## ZONE CHANGE REVIEW SHEET

**CASE:** C814-88-0001.10

Canyons @ Rob Roy Rezoning

Staff recommends Planned Unit Development (PUD) zoning with the following changes to Exhibit “H” of the PUD Land Use Plan -

# ORDINANCE CALCULATIONS

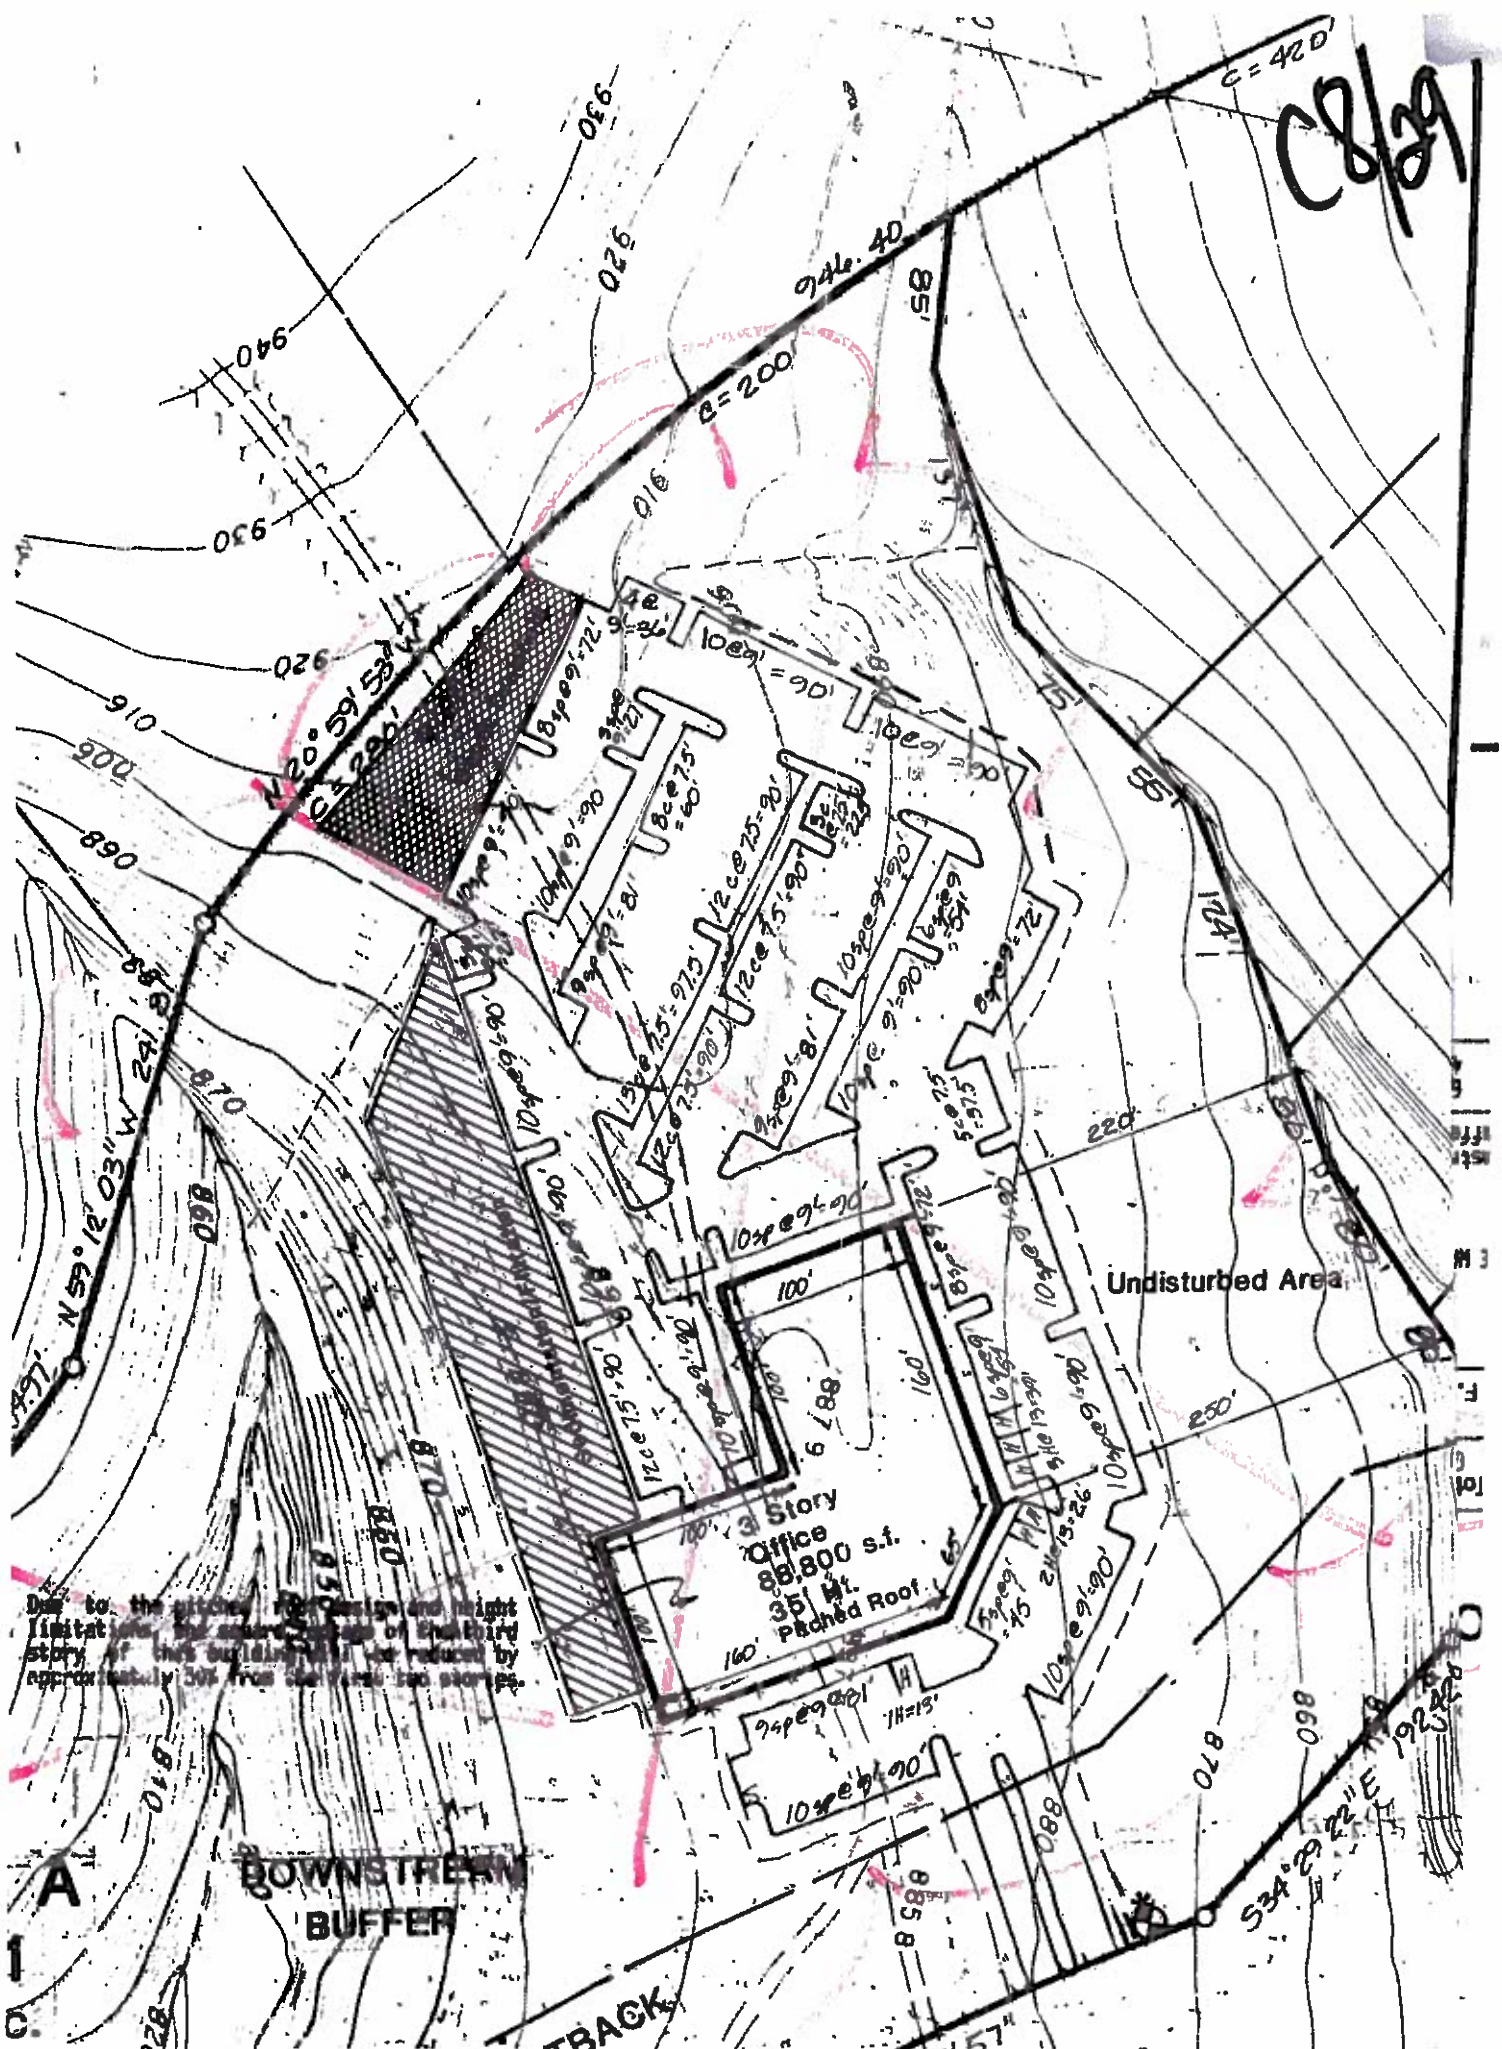
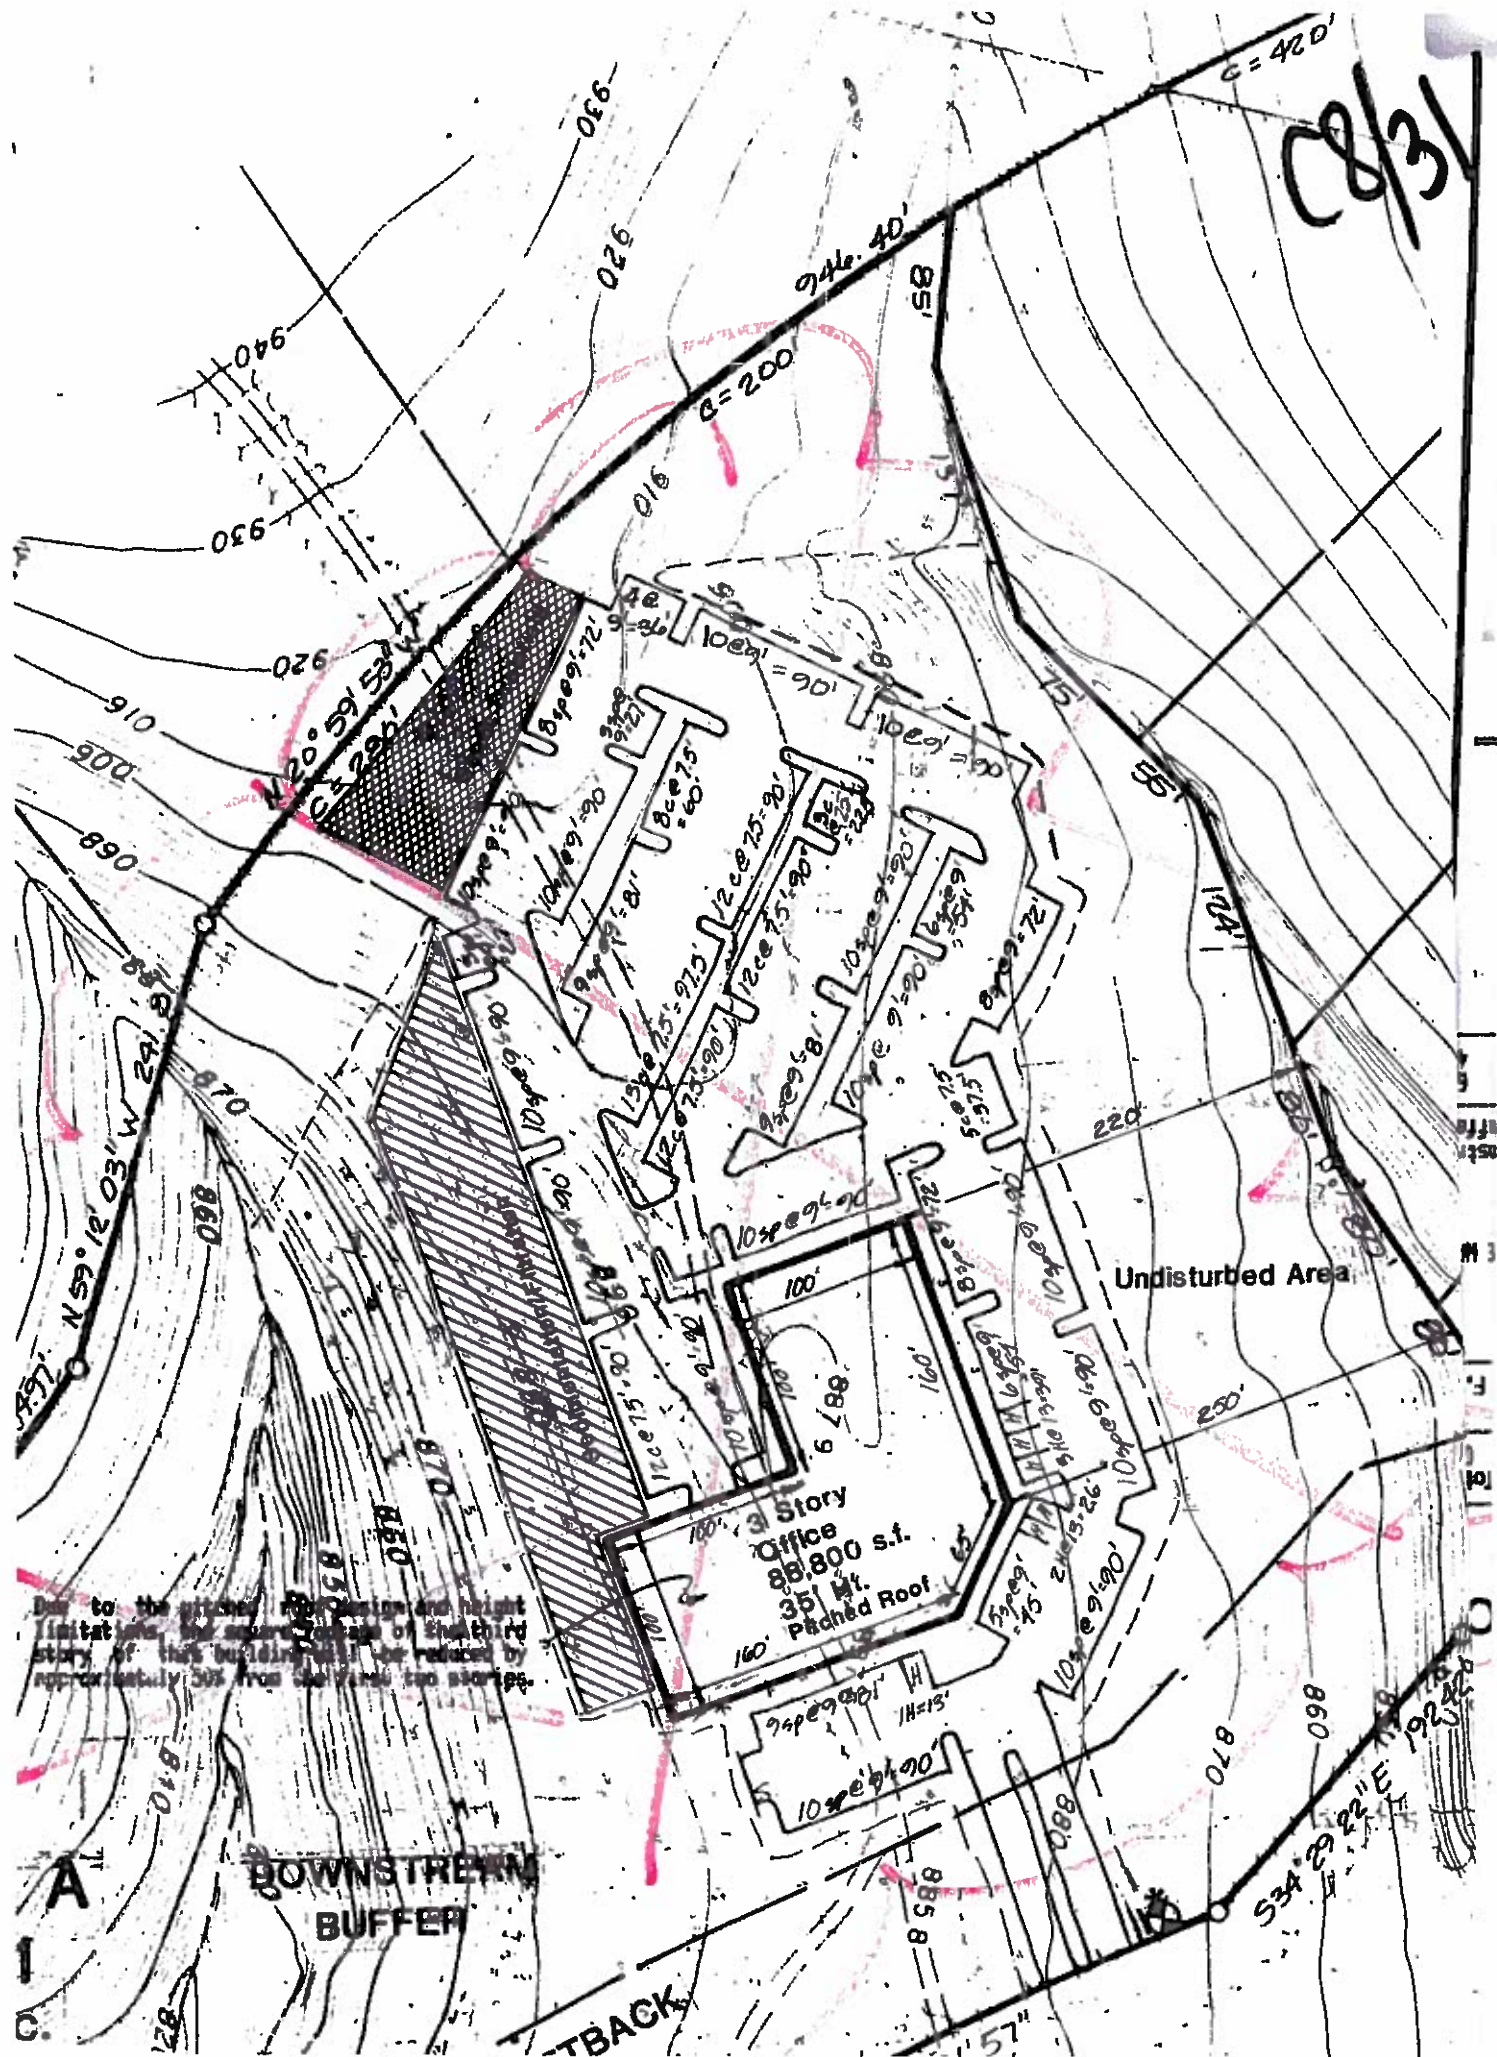
10. Remove the Hill County Roadway Ordinance Table on Sheet 3.
11. Change the Comprehensive Watershed Ordinance Table on Sheet 3 to reflect the proposed impervious cover.
12. Remove the diagram on Sheet 3 of the office project.
13. Add a note on Sheet 3 that clarifies the maximum height allowed on Lot A-1 is 35 feet.
14. Remove the note on Sheet 3 that reads "Due to the pitch of the roof design and height limitations the square footage of the third story of this building will be reduced by approximately 50% from the first two stories."

Exhibit "H" Land Use Plan. Remove the diagram on Sheet 3 of the office project.

Exhibit "H" Land Use Plan. Add a note on Sheet 3 that clarifies the maximum height allowed on Lot A-1 is 35 feet.

Exhibit "H" Land Use Plan. Remove the note on Sheet 3 that reads "Due to the pitch of the roof design and height limitations the square footage of the third story of this building will be reduced by approximately 50% from the first two stories."

7. The land use plan currently includes a map showing proposed commercial development along with undisturbed areas / downstream buffers. This map is proposed to be removed from the land use plan. If this map is to be removed, notes or a replacement map illustrating the undisturbed areas / downstream buffers must be added to the land use plan. The undisturbed areas / downstream buffers must be clearly shown in the land use plan revision.

Justification. Zoning is used to establish the best use for a site and should not be used to dictate the location of site improvements. This should be deferred to the site development stage when engineered documents and related reports are available to assess the proper location of improvements based on site constraints. Also by removing the diagram from the land use plan it prevents future amendments to the PUD should the location of the site improvements fluctuate slightly.

Justification. There is no change from the previous proposal.

Justification. This note is unnecessary since the building is limited to 35 feet with height limit exceptions, as prescribed by 25-2-531 of the City Code, for certain architectural elements including pitched roof designs.
